P96-092 - HOME SAVINGS ATM DRIVE THROUGH

- REQUEST:
- A. Special Permit to construct a free-standing Drive-Up ATM kiosk with rain canopy for an existing Home Savings Bank on 2.915 developed acres in the Point West Planned Unit Development (SC-R PUD) zone;
 - B. Variance to reduce the required ATM setback from 50 feet to 34 feet;
 - C. Variance to reduce the required Drive-Through stacking lane from 180 feet to 160 feet;
 - D. Plan Review to allow the construction of a free standing Drive-Up ATM in the SC-R PUD zone.

LOCATION: 1950 Arden Way
APN 277-0271-007 & 017
Council District 3

Elevations

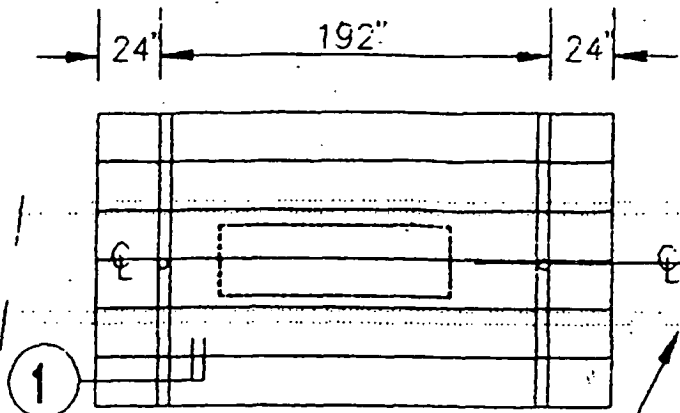
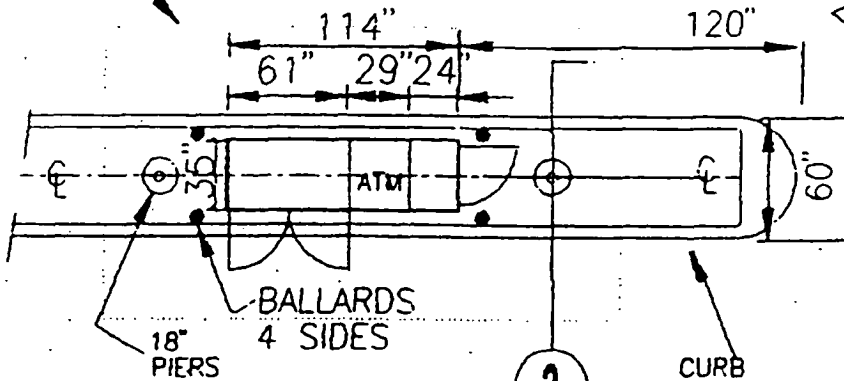
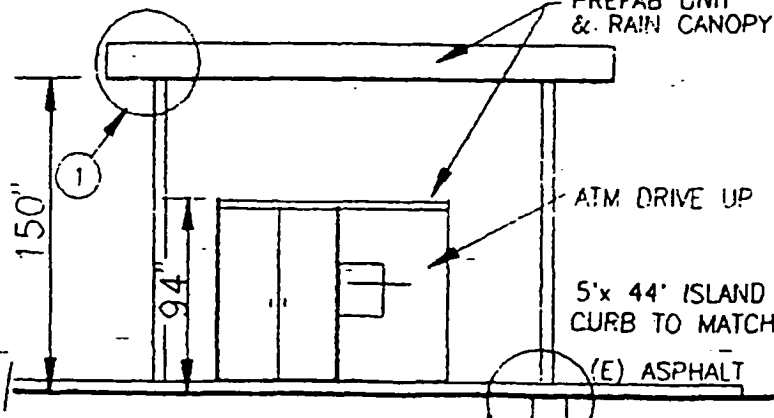
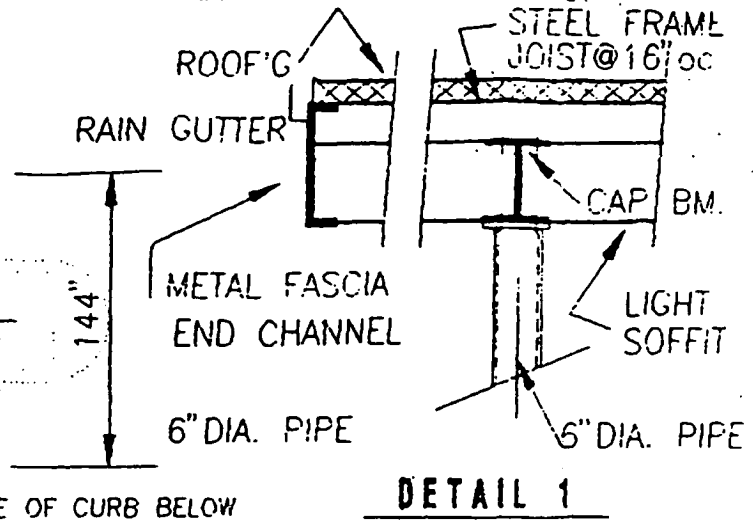
The applicant has indicated that the project will utilize with metal materials for construction painted light beige and earth tone brown trim. This color is compatible with the surrounding uses.

Site Plan

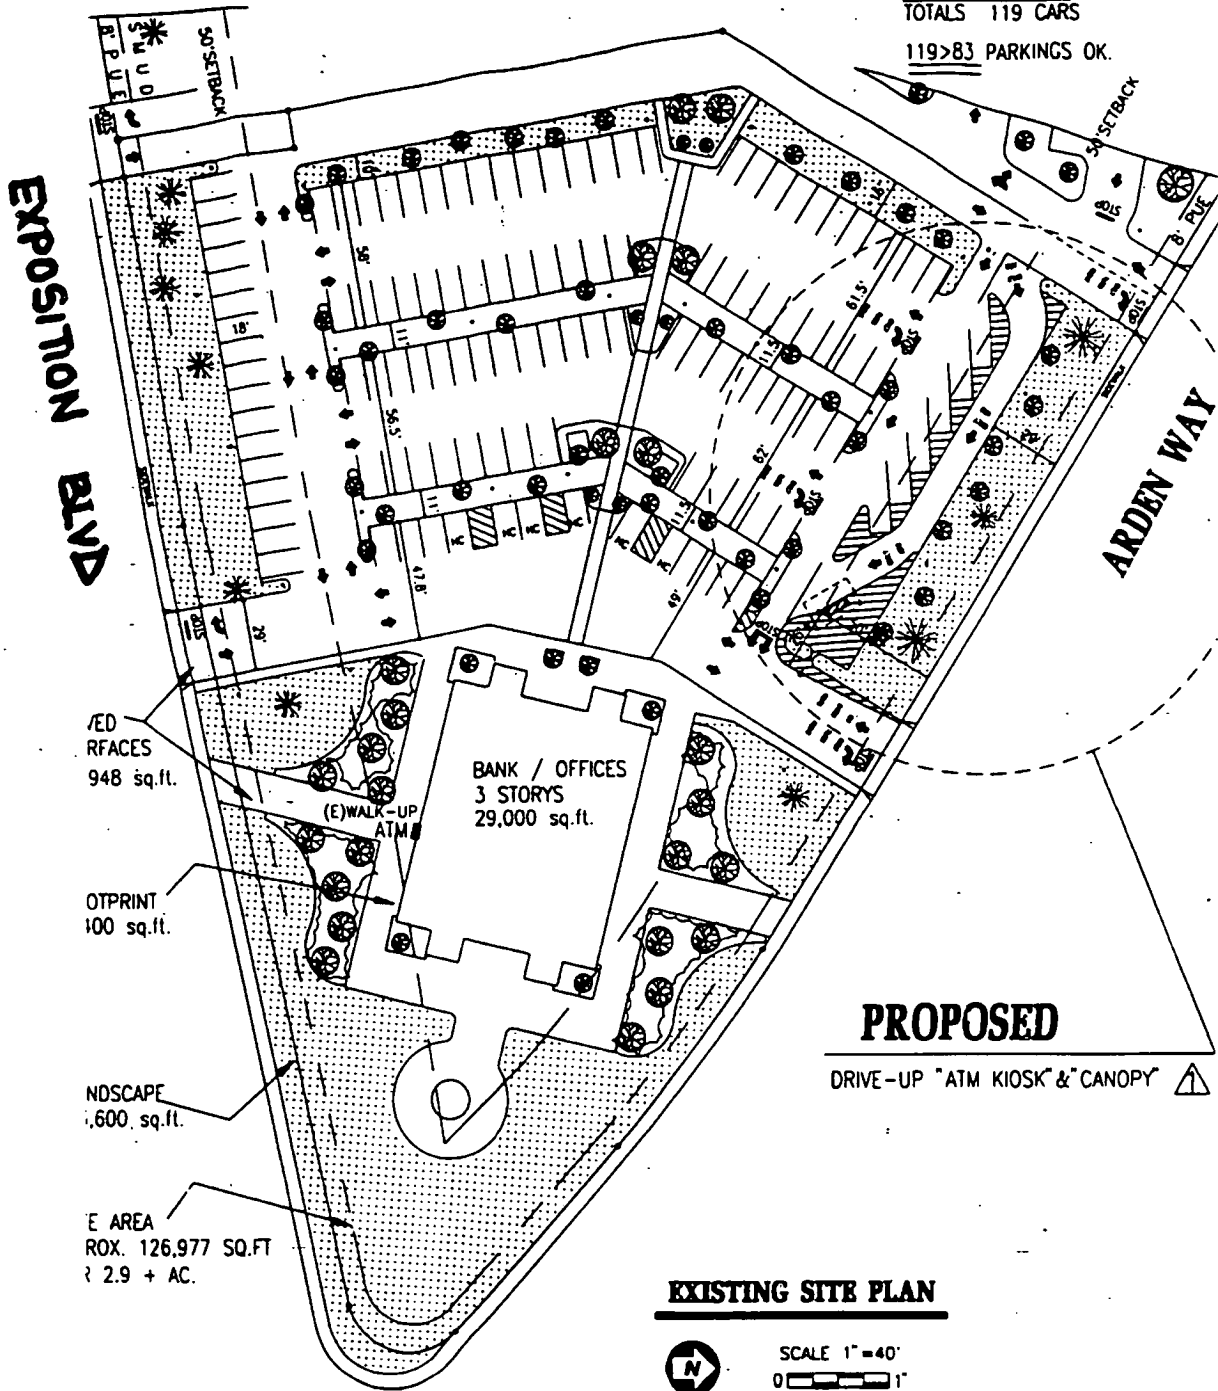
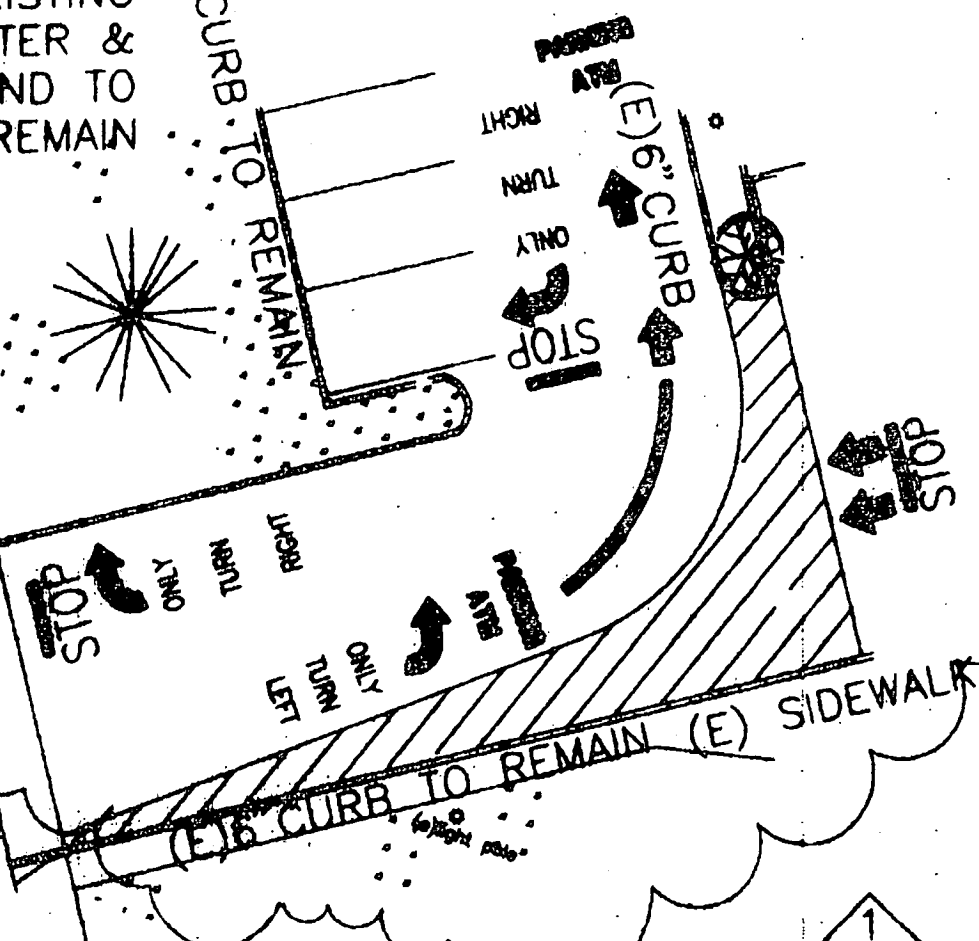
Specifically, the ATM kiosk is set back at least 42 feet from the Arden Way sidewalk exceeding the 5 foot street side yard zoning ordinance requirement for accessory buildings. The kiosk is also set back 25 feet from the driveway adjacent to the Home Savings Bank building and has a setback of 160 feet from the driveway shared with Mervyn's parcel to the north of the subject site.

The City's Zoning Ordinance requires a minimum of 1 parking space per 350 square feet of uses within Planned Unit Developments. This results in a parking requirement of 83 spaces. The subject site presently has 131 parking spaces existing and proposes to eliminate 12 existing parking spaces, leaving 119 spaces remaining on the site.

The ATM facility does not meet the minimum stacking distance of 180 feet and has requested a variance to reduce the stacking length to 160 feet. According to the submitted site plan, the entrance to the drive-up lane is greater than 25 feet from the public street and exceeds the minimum lane width of 11 feet. The design clearly indicates the entrance to the lane and the direction of traffic flow with signage and raised curbs.

The site plan indicates that 6 lagershoemia indica trees, 12 juniperous compacta, 7 raphiolepis bellerina and redwood chips over soil and between plants will be used to landscape the site.

The original project was revised to reflect the Transportation Division's opposition to any new driveways, particularly off of Arden Way. The proposed drive-through does not meet the 180 feet zoning ordinance requirements for stacking distance. Public Works would prefer a site plan that relocates the drive-through entrance farther away from the driveway (which is shared by the Bank and Mervyn's on the adjacent parcel).

Staff has however worked with applicant to revise the site plan to develop a compromise design. The objectives were to ensure the driveway areas on either end of the drive-through are kept clear and would not affect traffic operations on Arden Way. Conditions to guide circulation through the site are included below in the conditions of project approval.
